Response to Request for Further Information

*Deniliquin East BESS-SSD-
61612229*

Figure 1 Potential Alternative Landfill Locations – their feasibility will be clarified within the final WMP

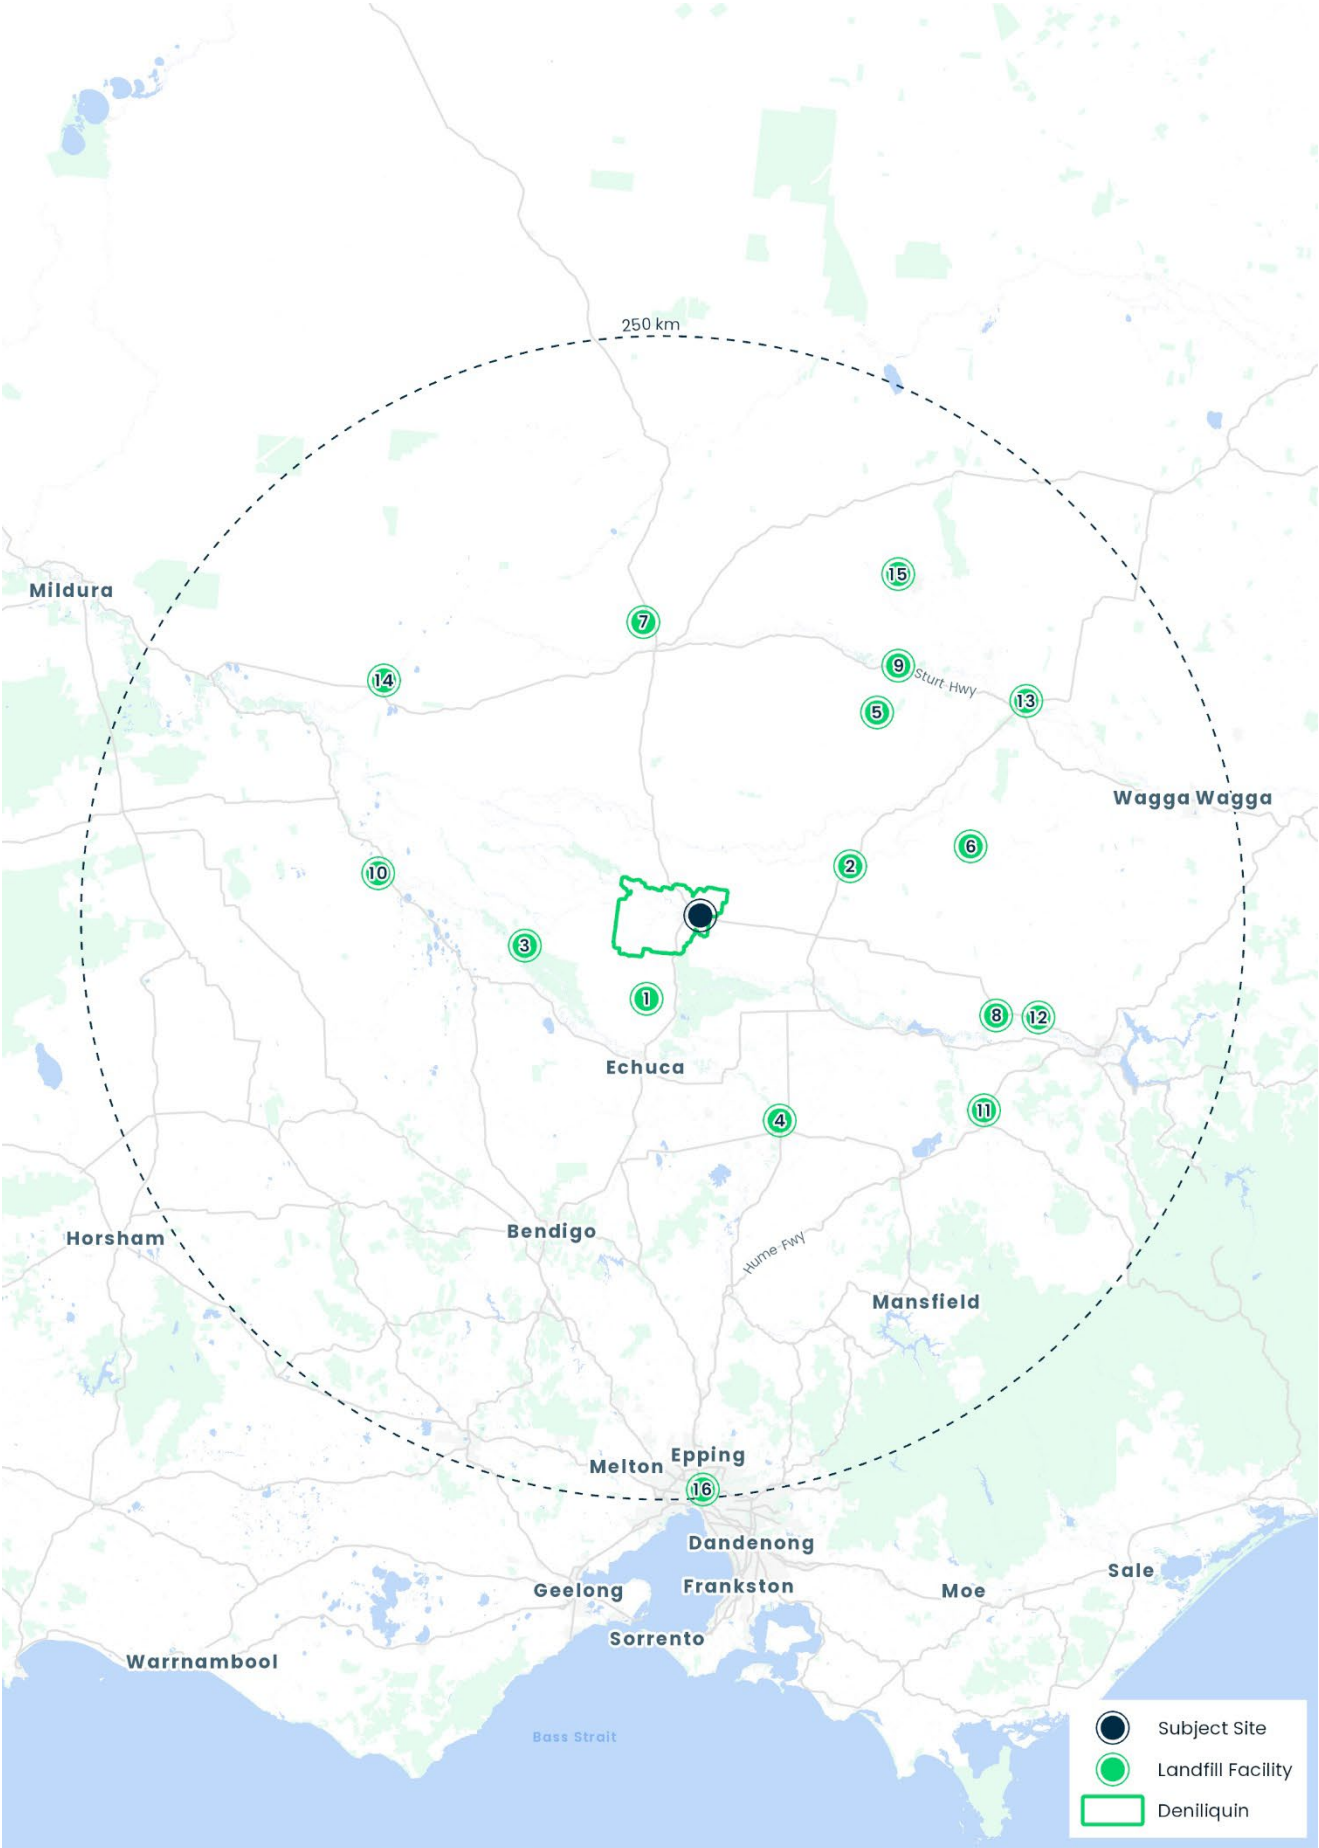
- **Wastewater:** The Applicant will source independent third-party contractors and arrangements to manage wastewater for the project.
 - **Waste Management:** Council confirmed that the Deniliquin Landfill is unable to accept waste from the project. The Applicant acknowledges this position and will review the Waste Management Plan (**WMP**) in consultation with Council prior to construction commencing to identify locations for disposal of construction and operational waste and will engage third-party contractors to deliver the requirements of the final WMP. A preliminary review of regional landfill locations has identified potential alternative sites for disposal that will be considered during the finalisation of the WMP prior to commencing construction. These alternate sites are shown in **Figure 1 and Table 1** below. The Applicant accepts a condition of consent requiring an updated WMP to be prepared prior to commencement of construction.
